10 January 2022

BLM Office Renovations
Pearl Public School District – Pearl, MS

ADDENDUM NO. 01

1 WALL SECTION A
3/4" = 1'-0"

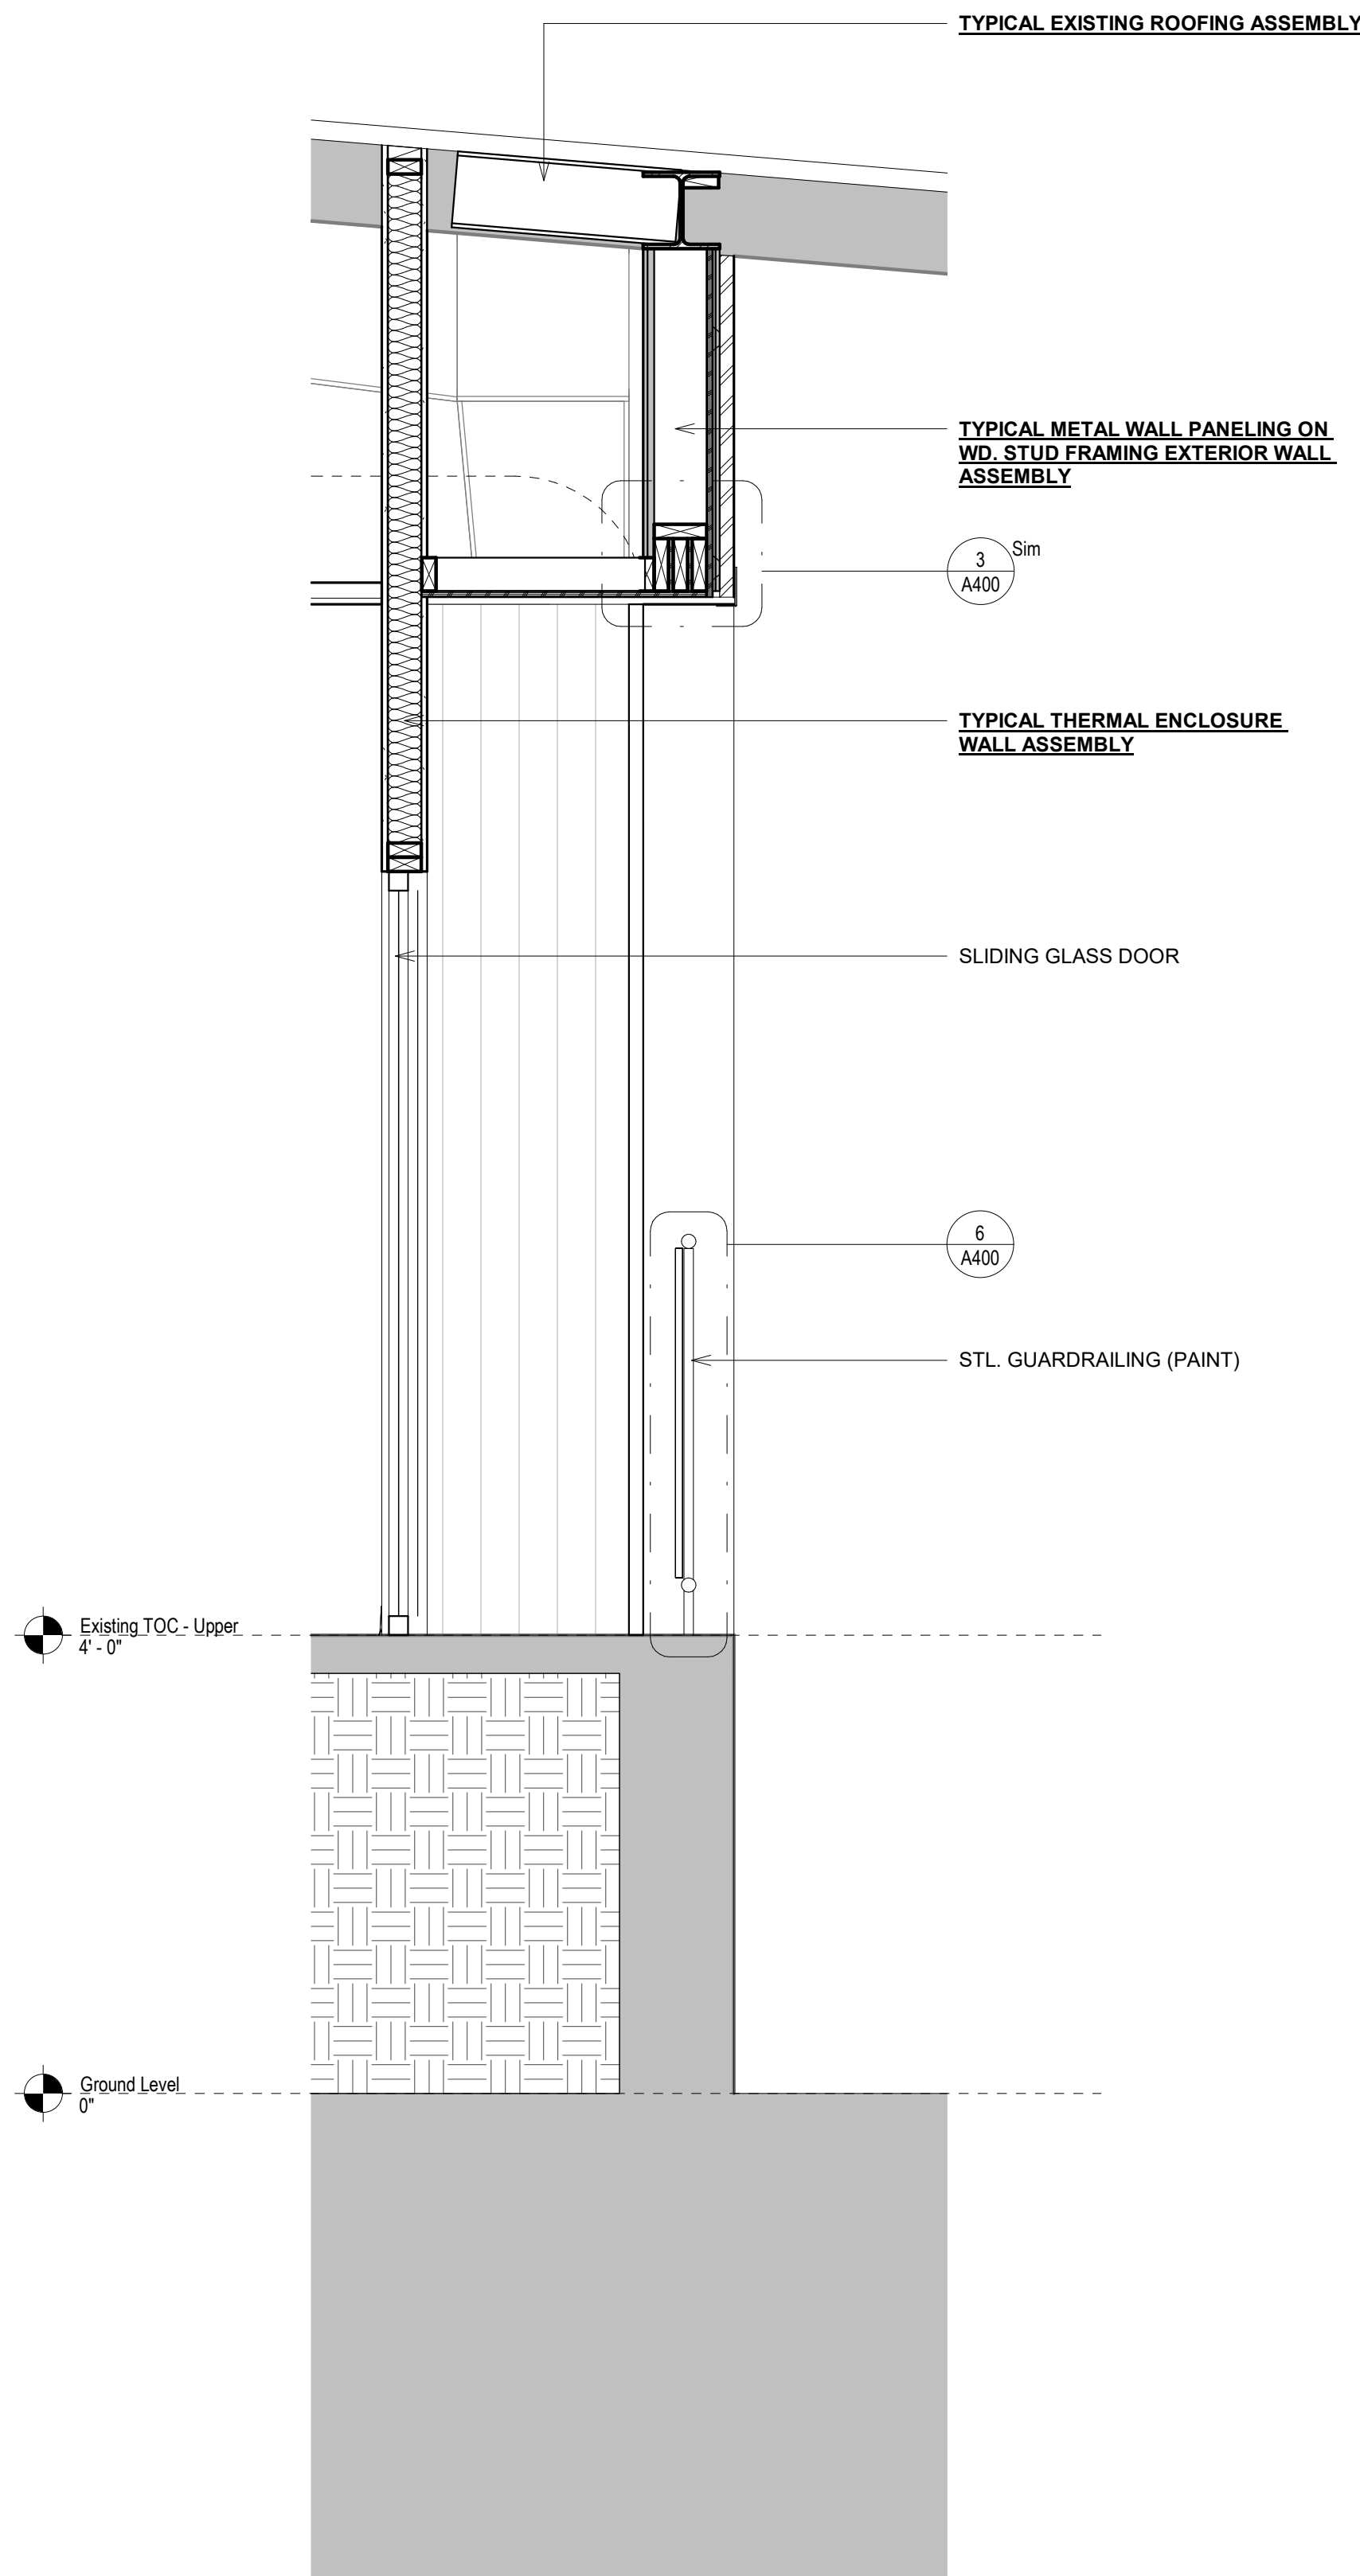
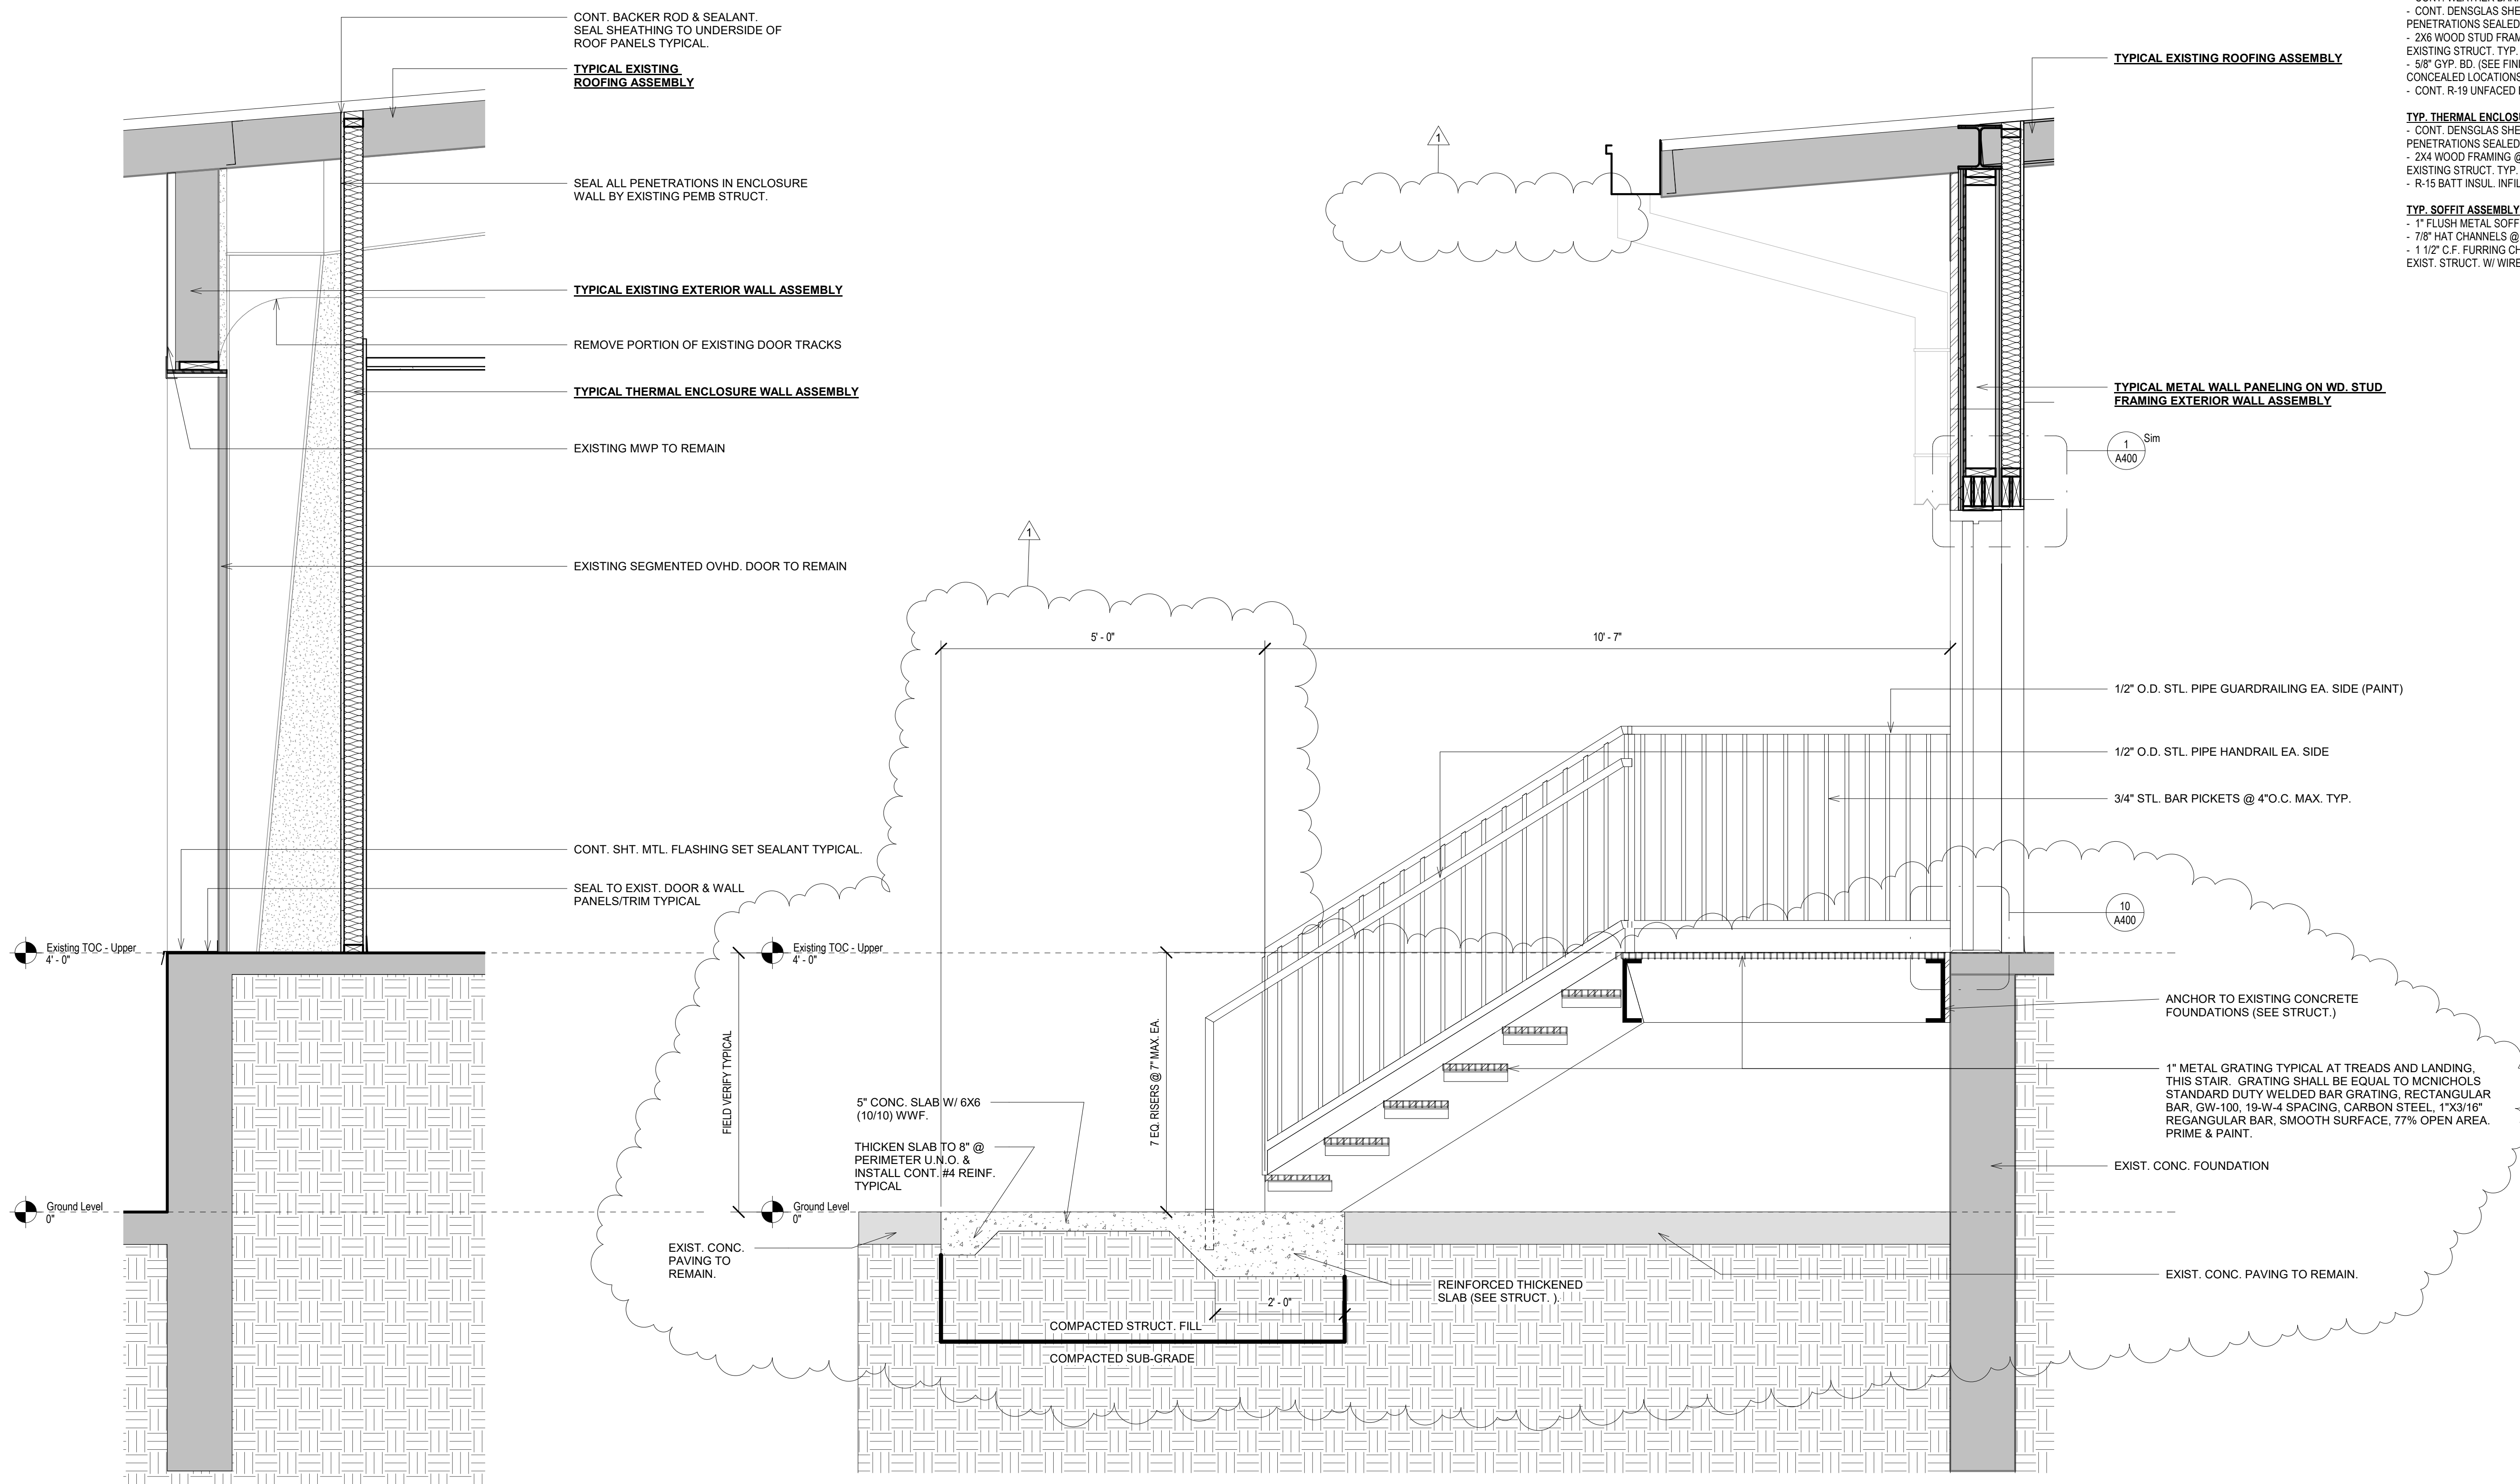
| ITEM NO. 9 | <p>A300 WALL SECTIONS</p> <p>A301 WALL SECTIONS</p> <p>A302 WALL SECTIONS</p> <p>A303 WALL SECTIONS</p> <p>Revise per the enclosed sheets.</p> |
